#### GENERAL COMMENT FOR ALL DWGS:

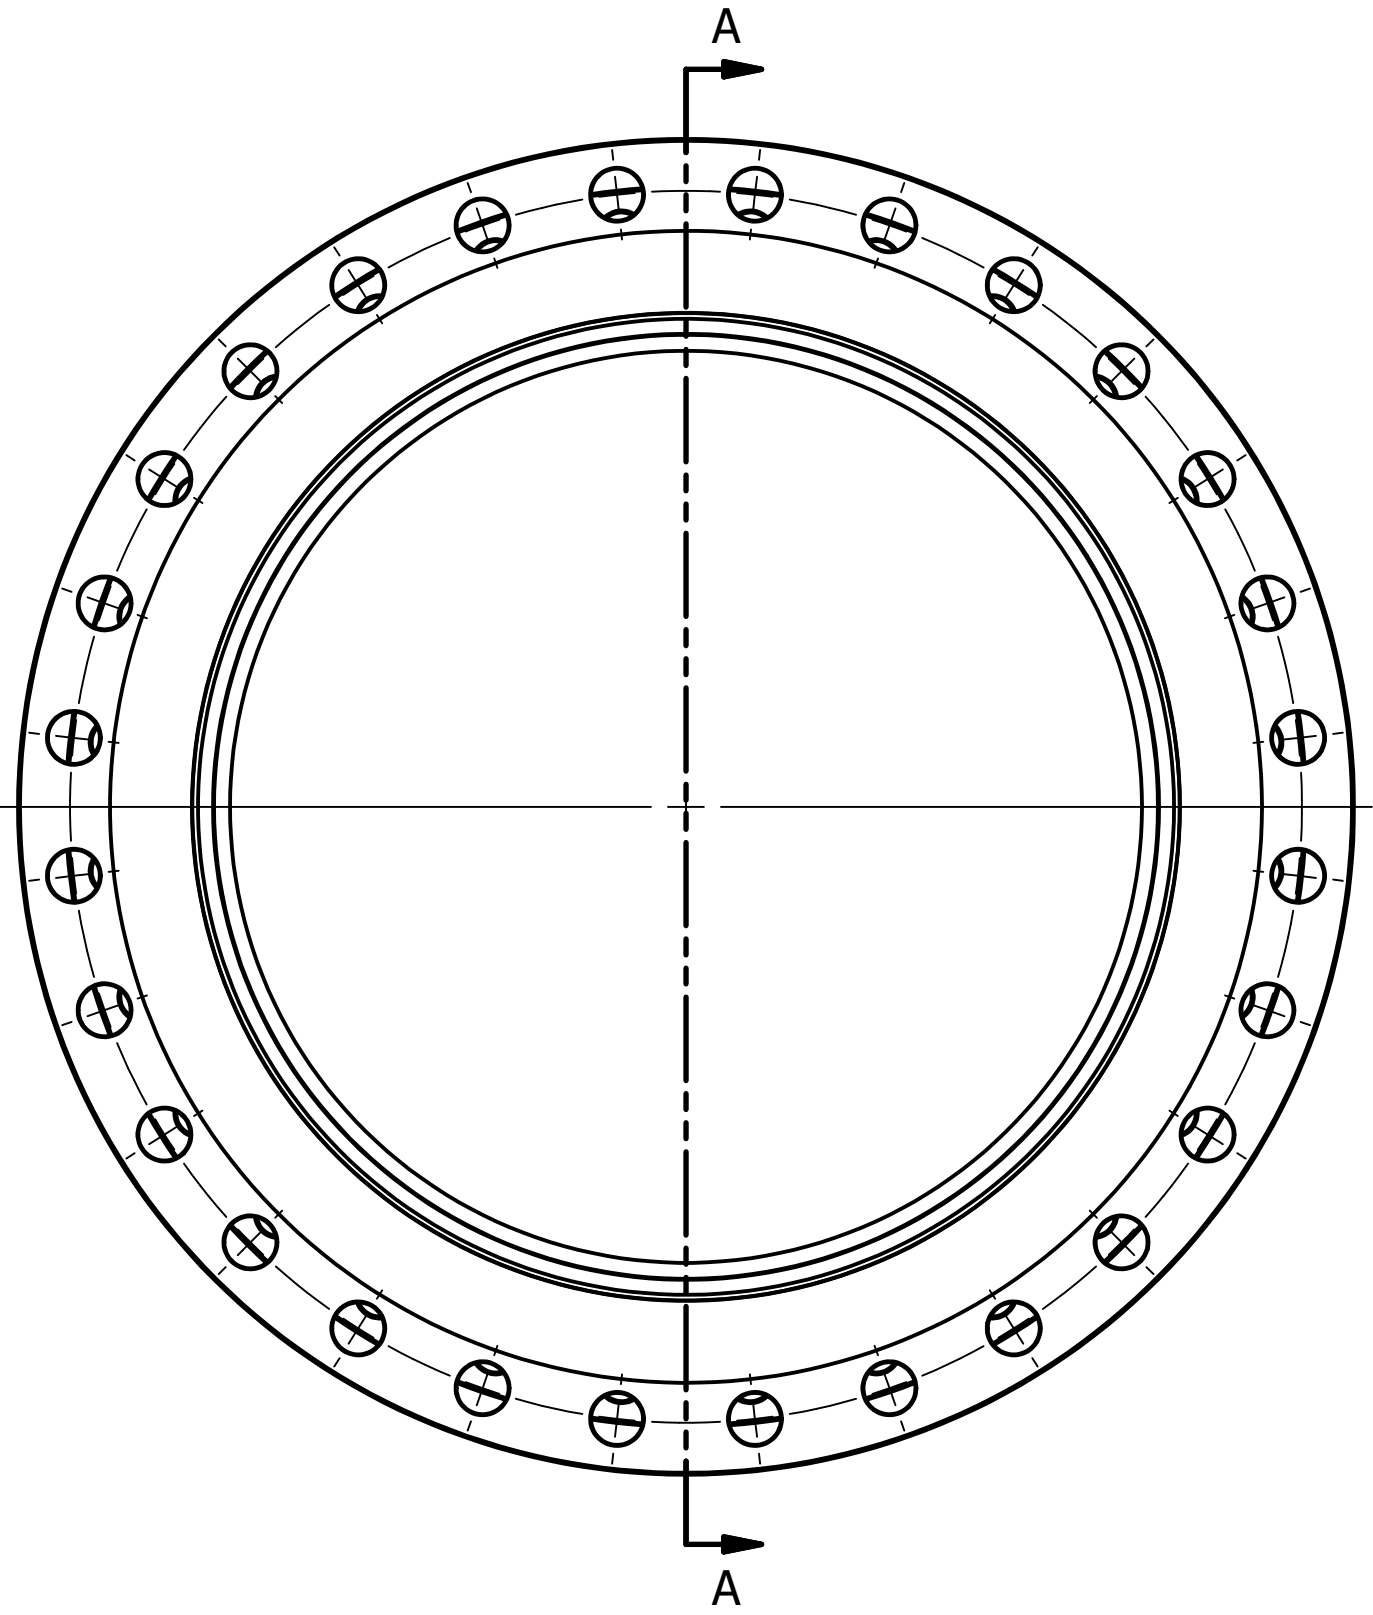
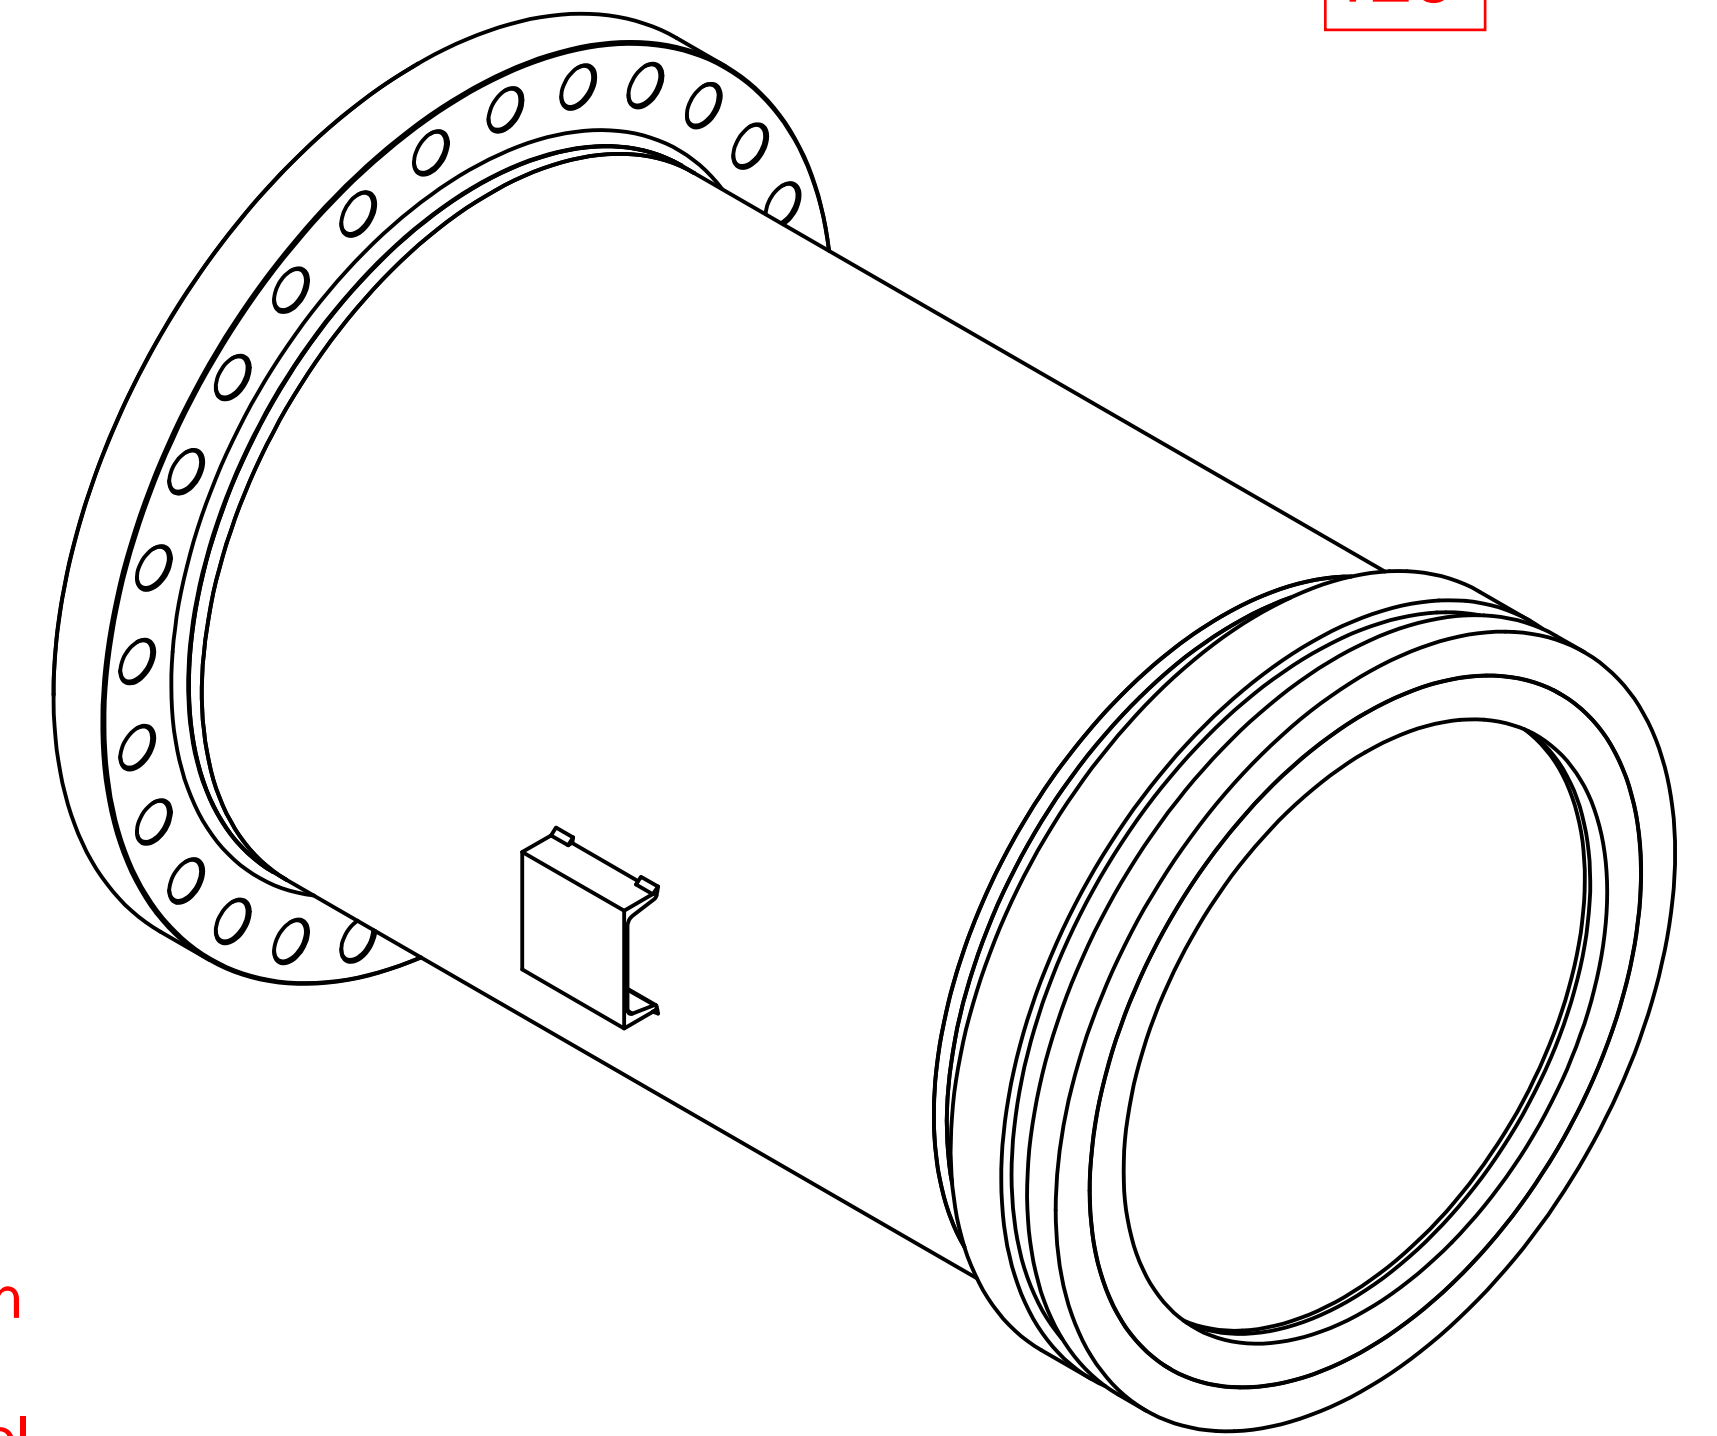
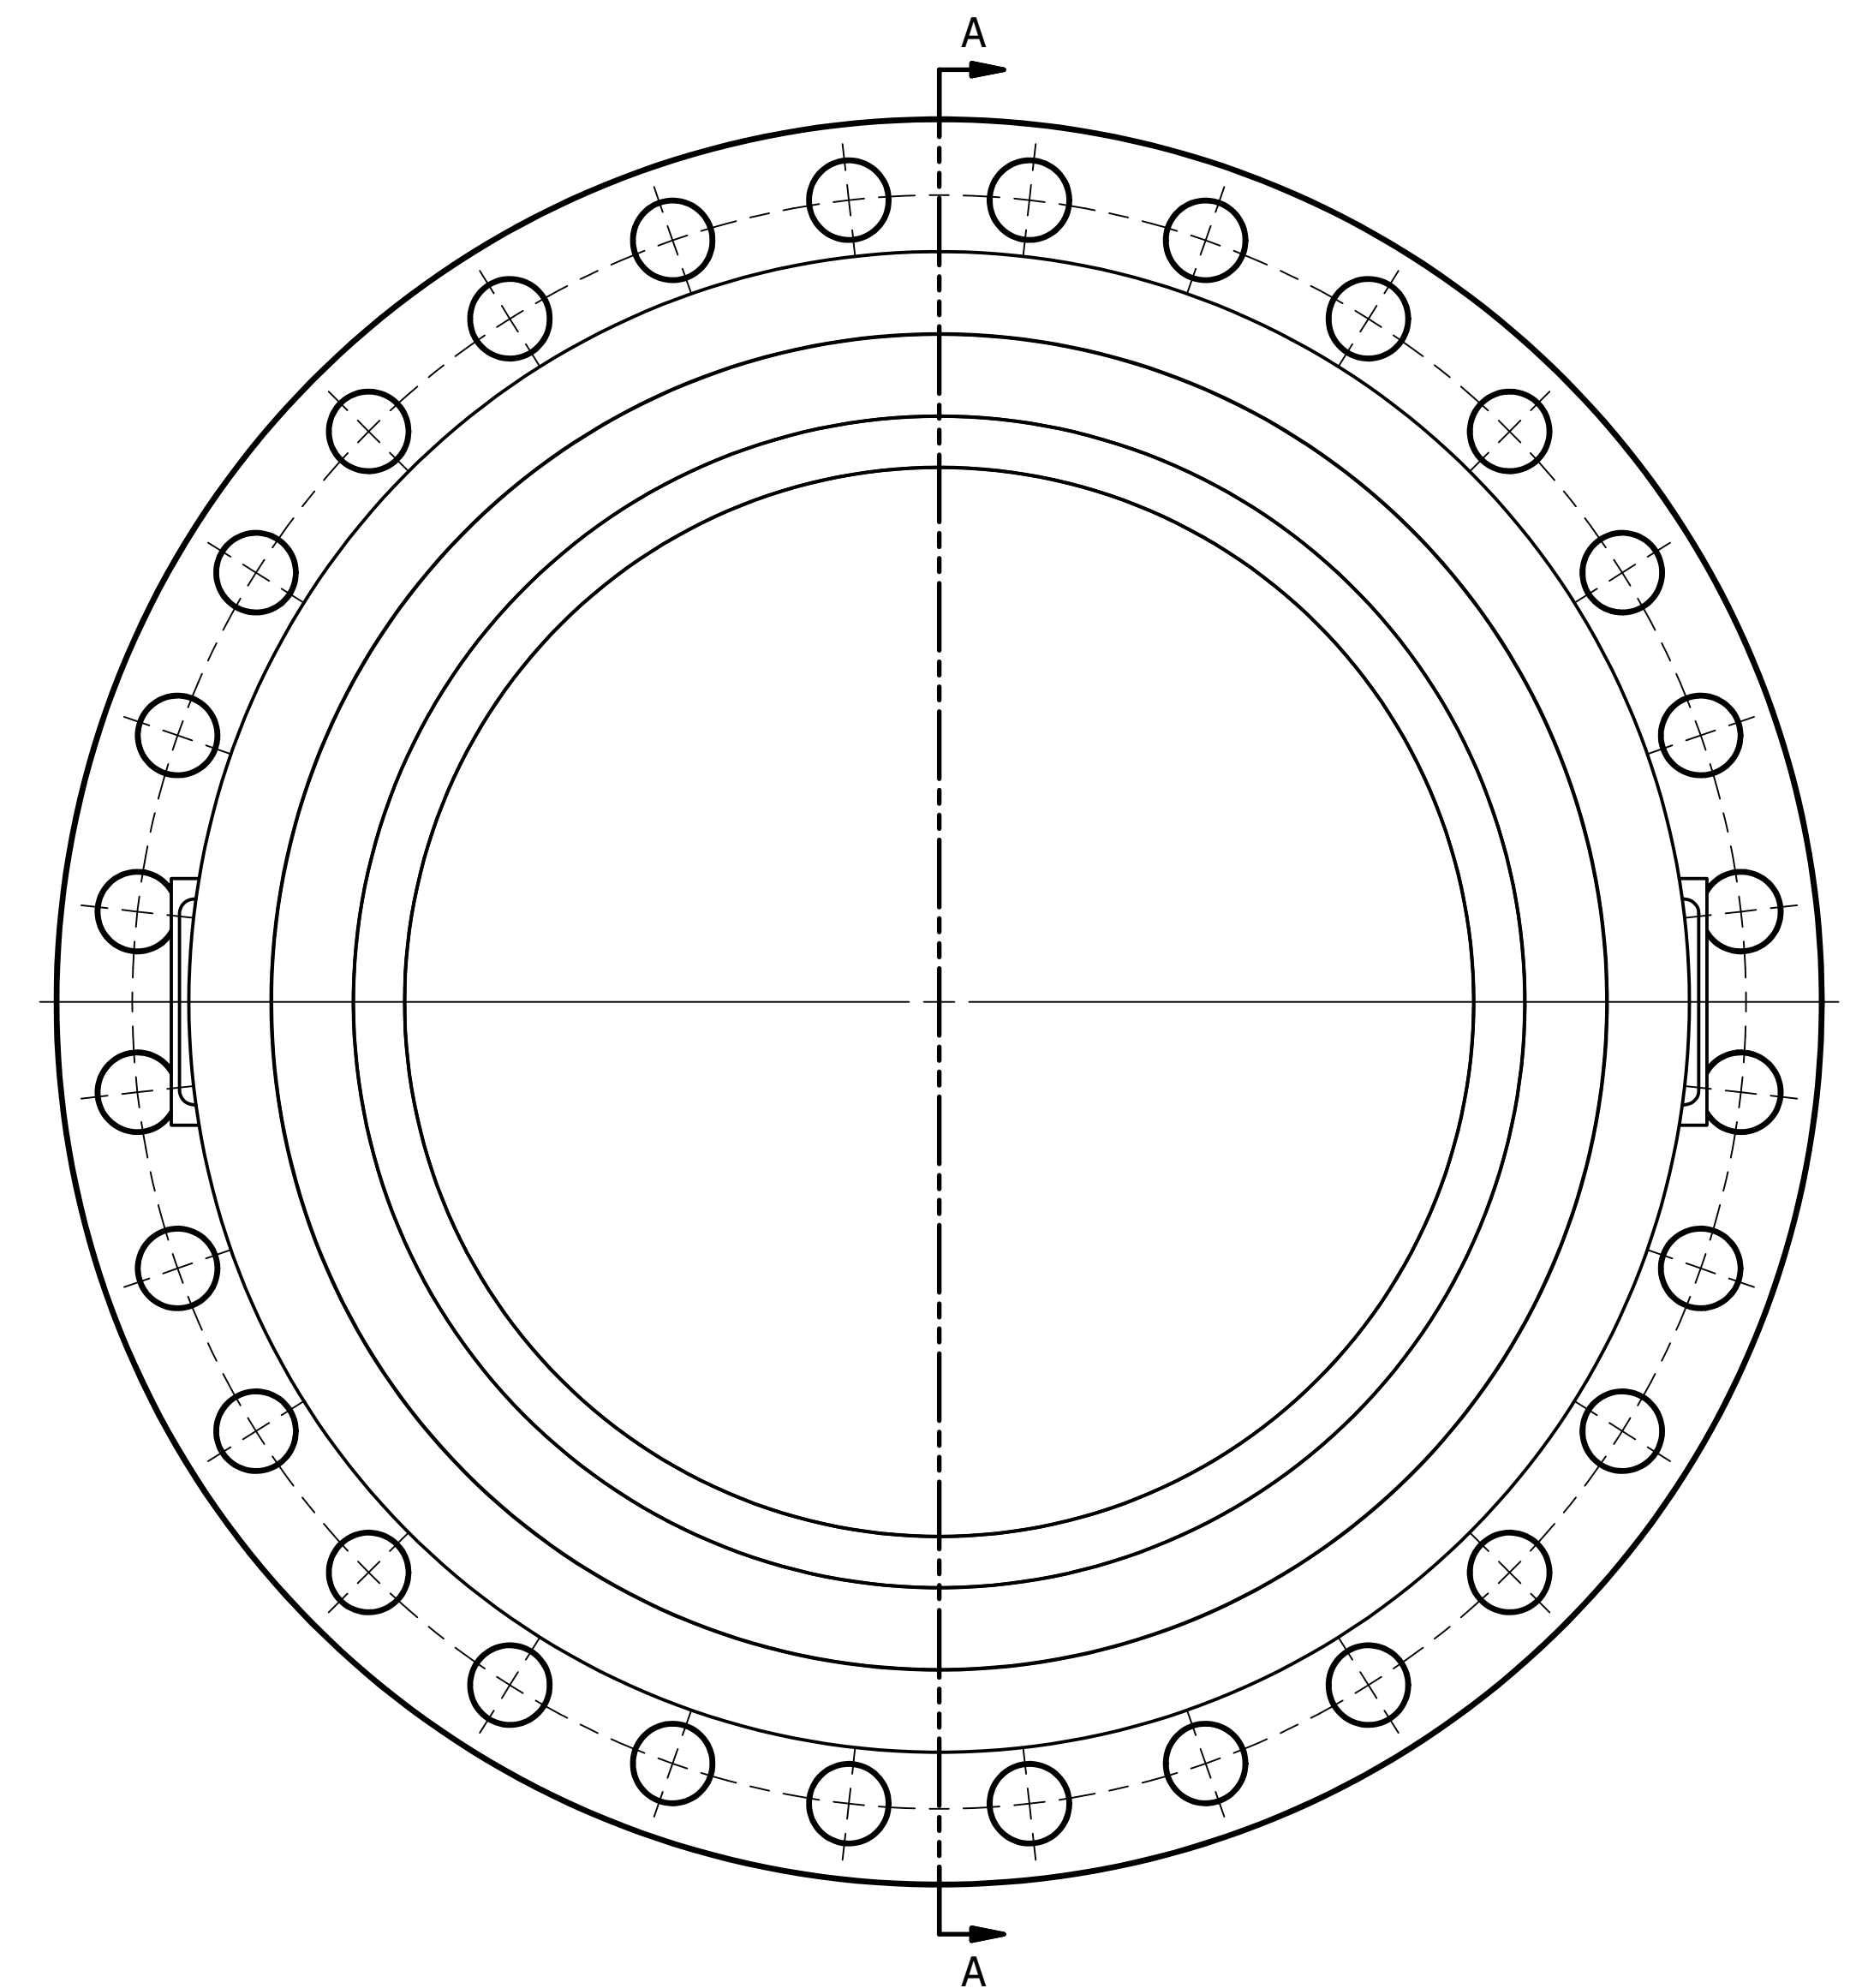
Note: Hydrotest Pressure has been updated to 2950 Kpag for this spool
